Re: Georges Cove Marina at 146 Newbridge Road, Moorebank - Response to RMS matters

This letter has been prepared in response to the traffic related matters that have been raised by Roads & Maritime Services (RMS) (now Transport for NSW (TfNSW)) in their letter dated 8 November 2019 in regard to construction and operation of Georges Cove Marina located at 146 Newbridge Road, Moorebank (TNSW Ref: SYD18/01728/03, Council Ref: DA-611/2018).

The distributions of these development traffic are presented in Figure 1 to Figure 5.

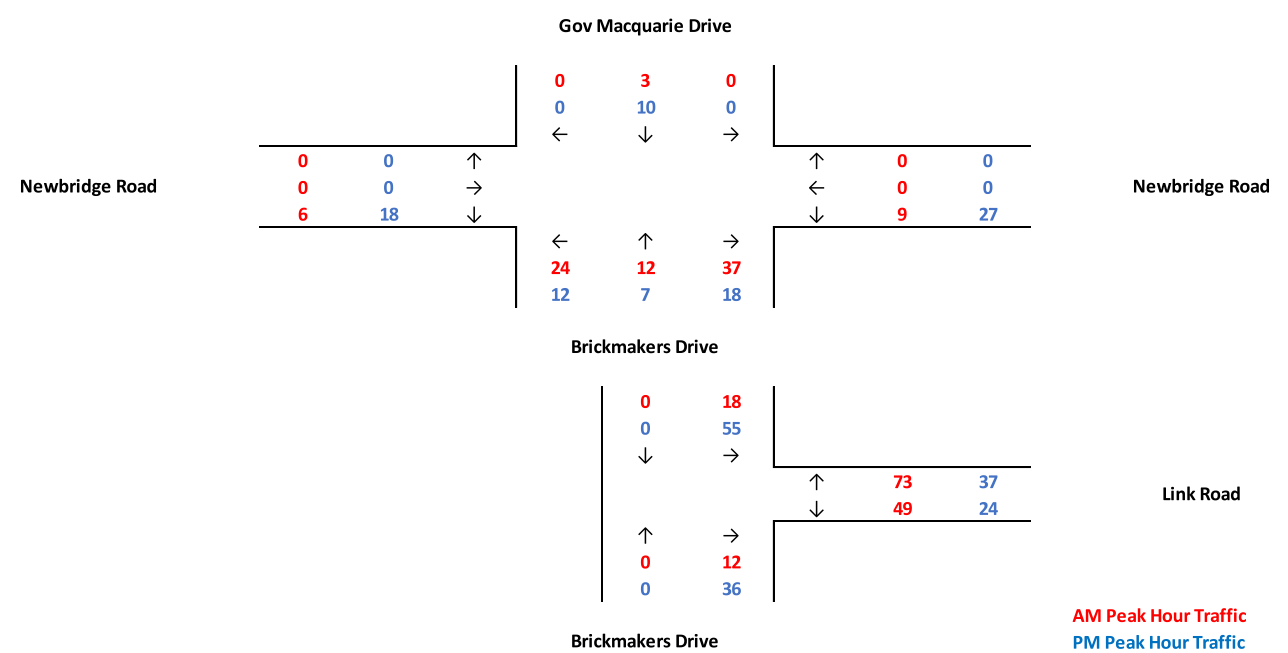
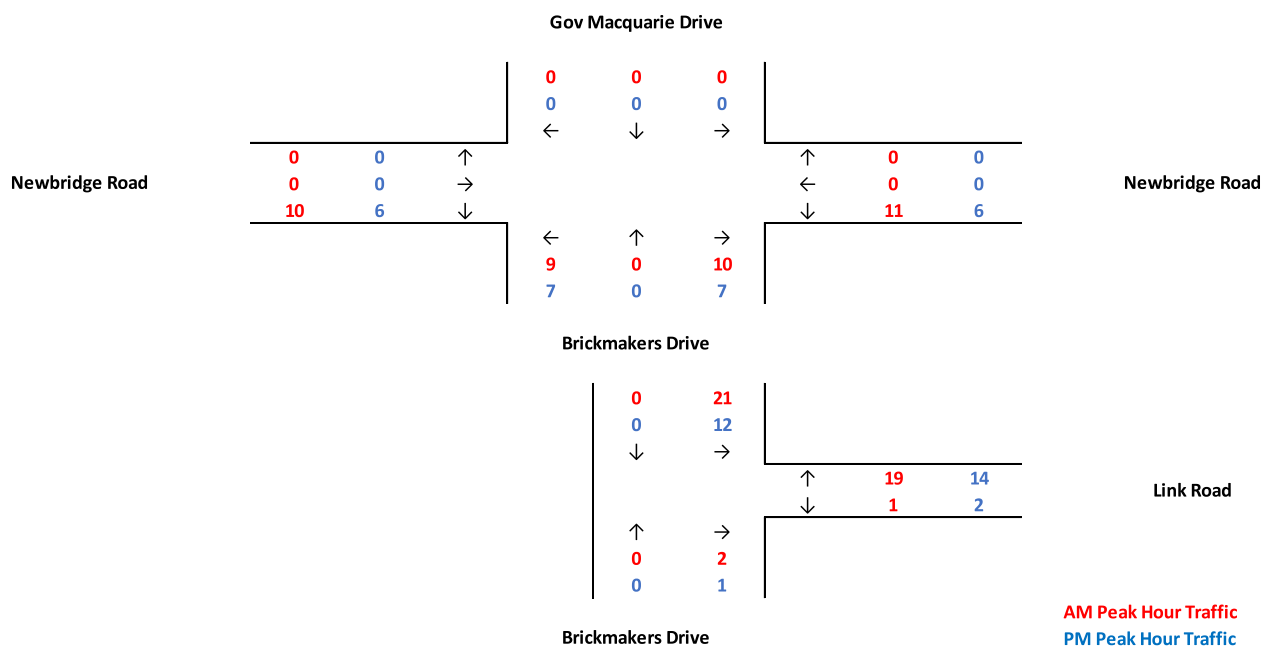
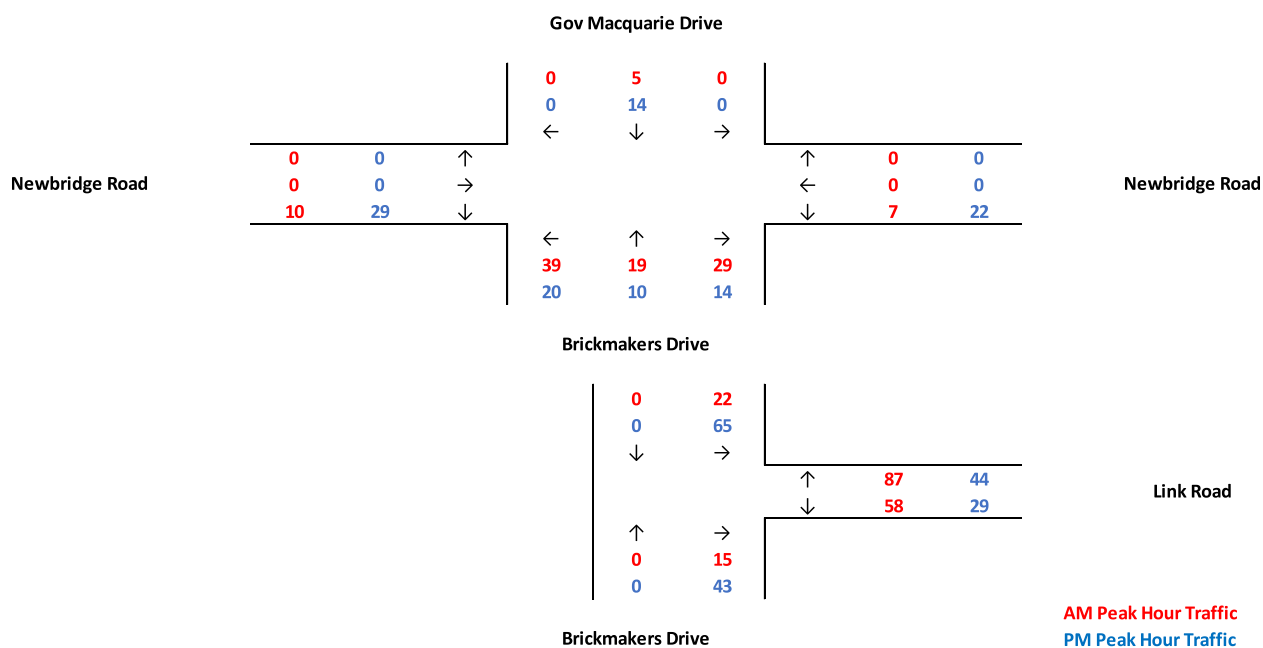
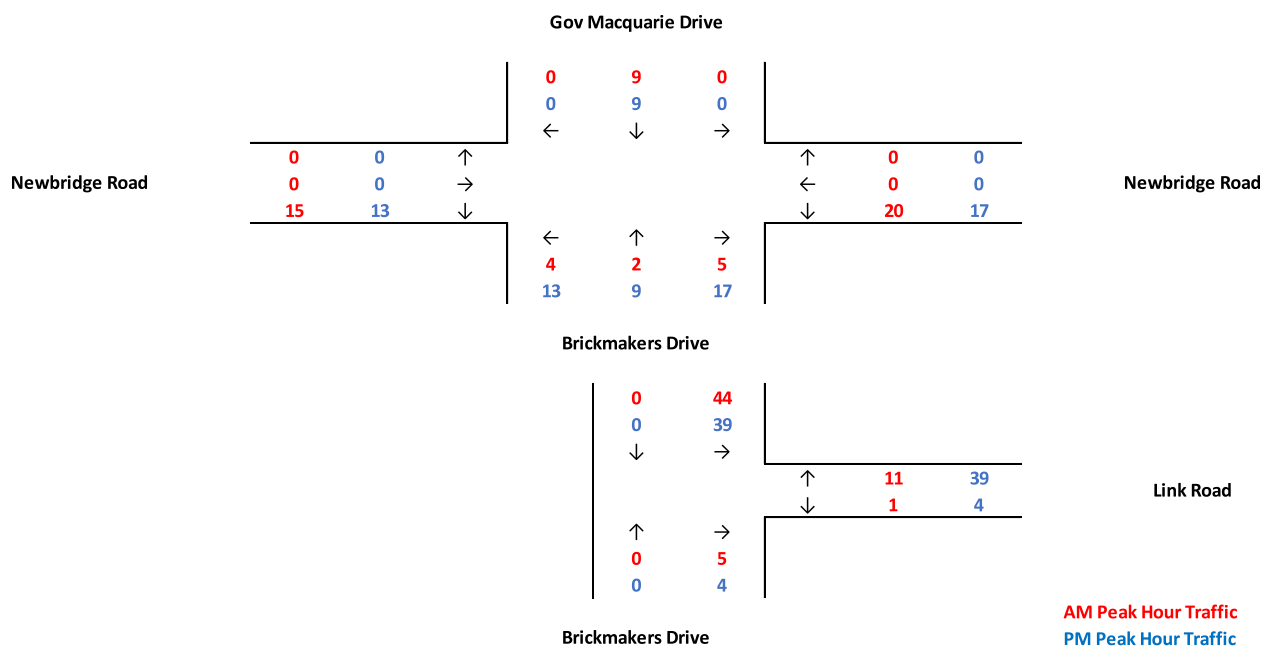
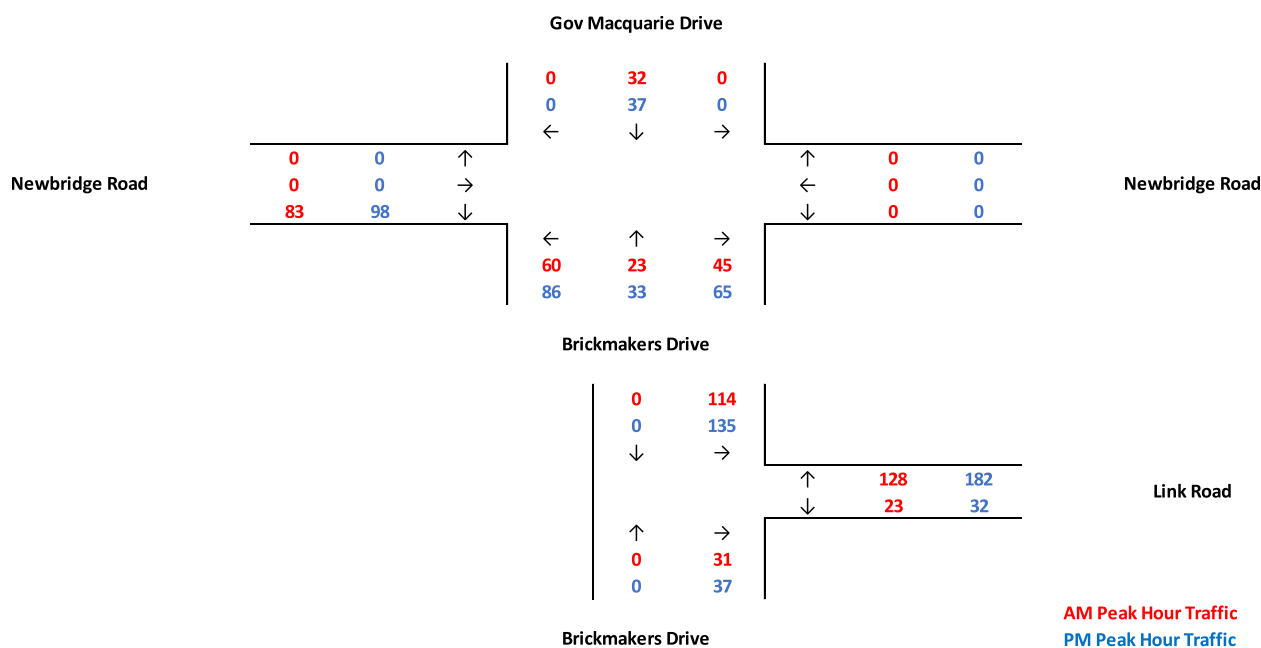
Further clarification is requested regarding the future development traffic volumes used in the submitted traffic assessment. For instance, when will these various developments be completed and using the new road connection to Brickmakers Creek [sic, presumably 'Drive']?

In accordance to the respective traffic studies, the generated traffic of the following proposed developments will use the Link Road off Brickmakers Drive. The following reports cover the future development traffic to/from the site:

The traffic generation and distributions of these developments were discussed in their respective traffic reports, a summary of these traffic generations is provided in Table 1.

Figure 7 Existing traffic movements

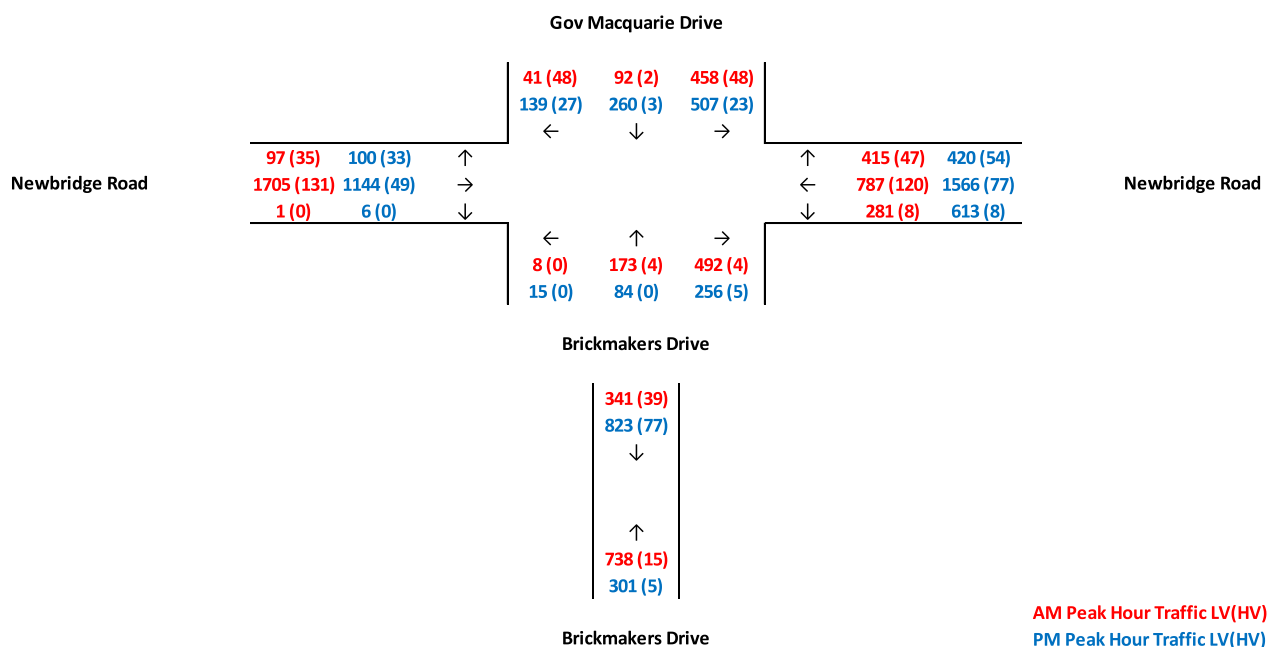
The submitted traffic model needs to be updated to include 2019 traffic count data in order to consider cumulative traffic growth since the lodgement of the original traffic applications for the various land uses at 146 Newbridge Road, Moorebank.

As mentioned in Section 1.1, a new survey was conducted at the intersection of Newbridge Road with Governor Macquarie Drive and Brickmakers Drive as well as on Brickmakers Drive at the new Link Road. The existing surveyed traffic movements are presented in Figure 7.

Figure 9 Signalised intersection layout

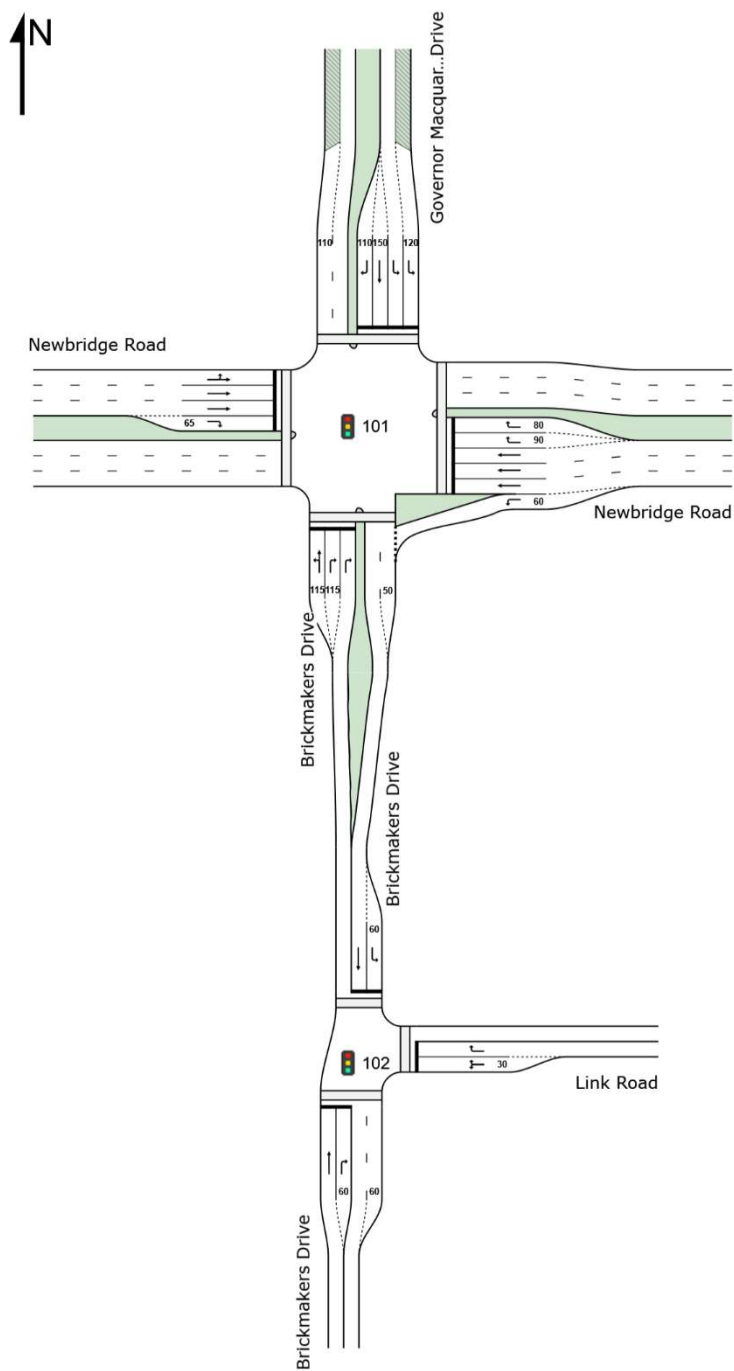
The SIDRA model needs to be updated to include 140 second cycle times.

The SIDRA model has been updated with 140 second cycle times. The roundabout option has also been explored in SIDRA as part of the sensitivity testing. Figure 9 and Figure 10 present the layout of the signalisation and roundabout respectively.

Signalisation of this intersection would result in a LOS E for right turning traffic from Link Road during the AM and PM peak hours with approximately 170 m queue length. However, the queue will be able to clear in during a single green-light (140 seconds) and thus is acceptable.
